**Mark B. Bezilla**  
Site Vice President724-682-5234  
Fax: 724-643-8069April 7, 2003  
L-03-065U. S. Nuclear Regulatory Commission  
Attention: Document Control Desk  
Washington, DC 20555-0001**Subject: Beaver Valley Power Station, Unit No. 1 and No. 2  
BV-1 Docket No. 50-334, License No. DPR-66  
BV-2 Docket No. 50-412, License No. NPF-73  
Revision 1 to Reply to Request for Additional Information Regarding  
Proposed Alternative Repair Methods for Reactor Vessel Head  
Penetrations (Relief Request No. BV3-RV-04)**

**Revision 1 to Reply to Request for Additional Information Regarding Proposed  
Alternative Repair Methods for Reactor Vessel Head Penetrations (Relief Request  
No. BV3-RV-04)**

### Beaver Valley Power Station (BVPS) Unit 1 & 2 Rev. 1 to Responses NRC RAI Questions (Relief Request No. BV3-RV-04)

**Figure 1**  
**Beaver Valley Unit 1 Stress Corrosion Crack Prediction for 0.5" Below Weld (Nozzle Uphill)**  
**Longitudinal Inside Surface (Aspect Ratio = 6:1)**

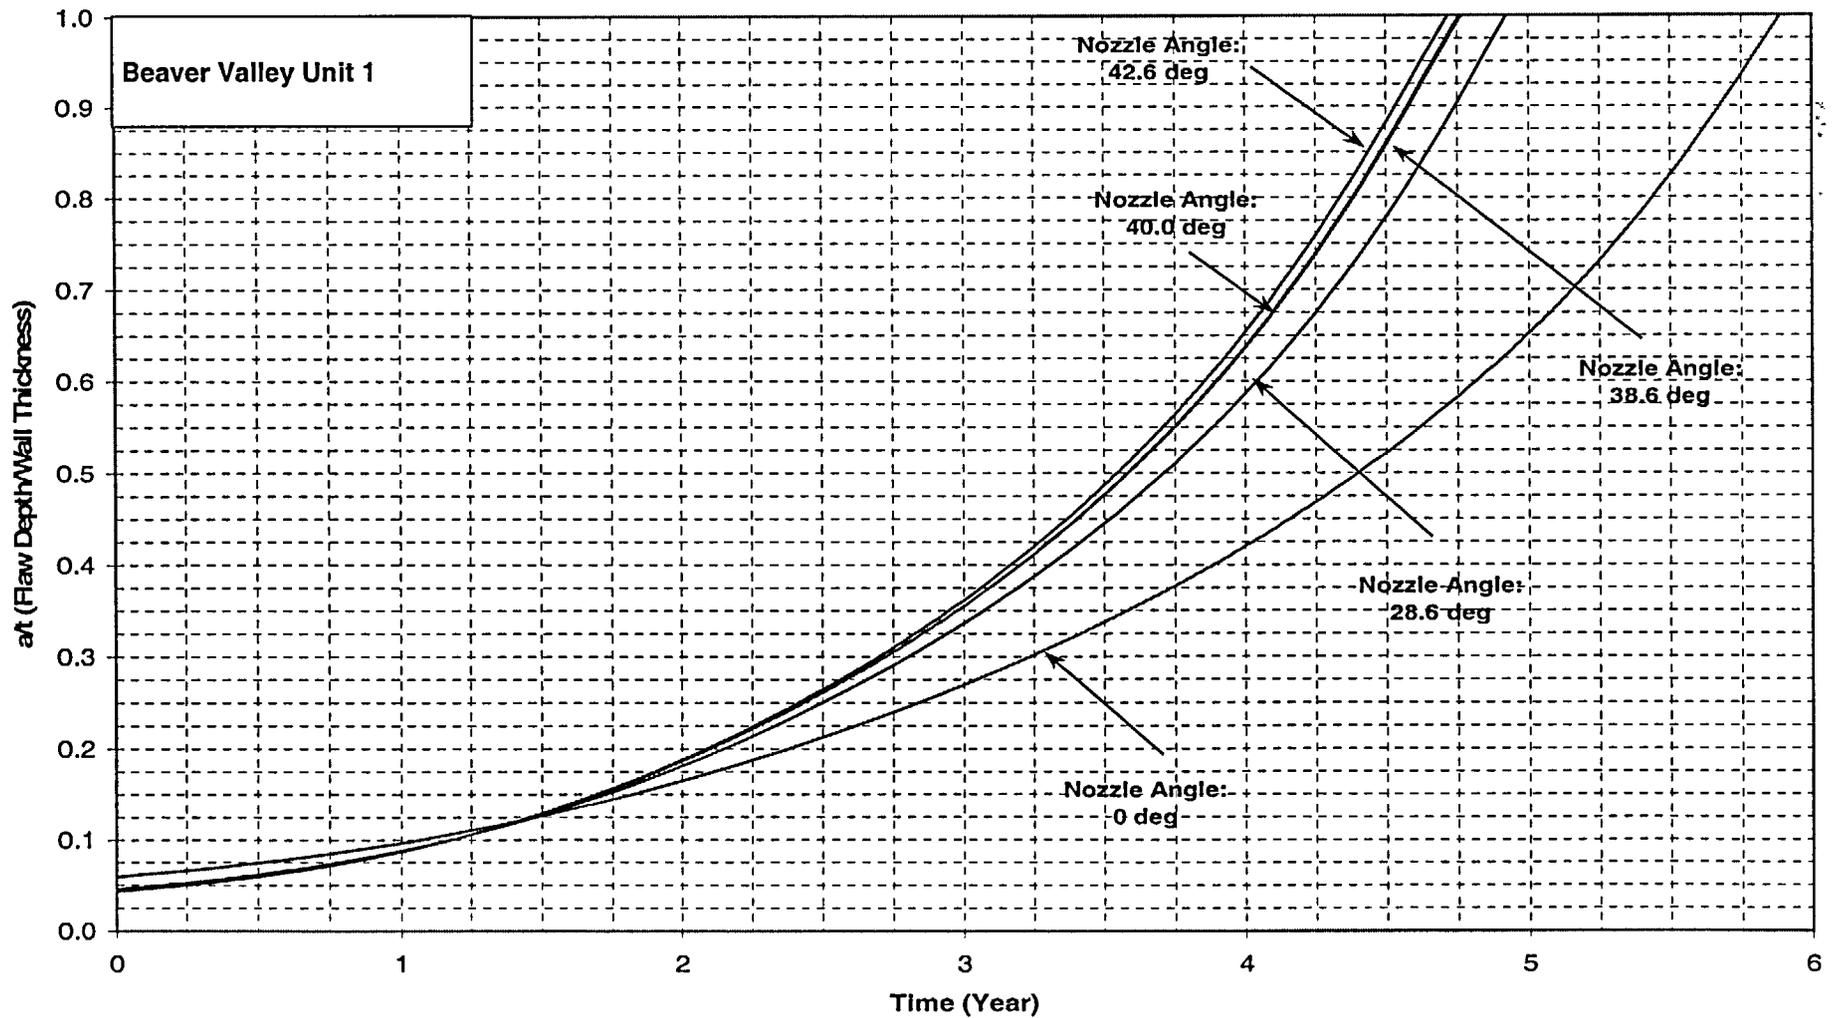
***Question 6. Considering residual, thermal and operating stresses, and the largest flaw that may be left on the nozzle inside surface post-repair, an analysis that demonstrates that this assumed flaw will not exceed the ASME Code flaw acceptance criteria of 0.75% through-wall prior to re-inspection should be provided.***

To further support the conservatism of this assessment, flaws were postulated at a location 0.5 inch below the attachment weld, and at either the uphill or downhill location on the tube. The results are shown in the attached Figures 1 and 2, which were prepared from an existing analysis of a Westinghouse 3-loop plant of similar design and construction to BVPS Unit 1. The specific results that apply to the BVPS Unit 1 penetrations being repaired (numbers 50, 51, 52, and 53) are for angles of 38.6 degrees. The angle mentioned is the angle of intersection between the tube and the head.

The crack growth calculations shown here used a methodology consistent with the recently approved Section XI flaw evaluation approach, with a PWSCC crack growth law that is consistent with the MRP-55 report. Figure 1 shows the results for an axial flaw on the uphill side of the nozzle. Curves were developed for a range of nozzle angles, but the governing case for Unit 1 is for an angle of 38.6 degrees, which corresponds to the angle of the tubes in which indications were found. It can be seen that at least 4.25 years are required to grow a flaw from the threshold for initiation at 9MPa sq-rt-m to a depth of 75 percent of the wall thickness. This is a very conservative calculation because the inspection has shown that there are no flaws of any depth on the inside surface of the penetration, and because no benefit was taken for the compressive residual stresses induced by the weld repair.

Another measure of the conservatism is to look at the size flaw that would grow to the ASME limit of 75% of the wall thickness in one fuel cycle. From Figure 1, it can be seen that a flaw depth of over 30% of the wall would be required to have such growth.

A more general approach would be to consider all the tubes, regardless of where indications might be found. The most limiting penetration in Figure 1 is the 42.6 degree penetration, and for this case at least 4.2 years would be required to grow a flaw to the allowable depth of 75 percent of the wall thickness.
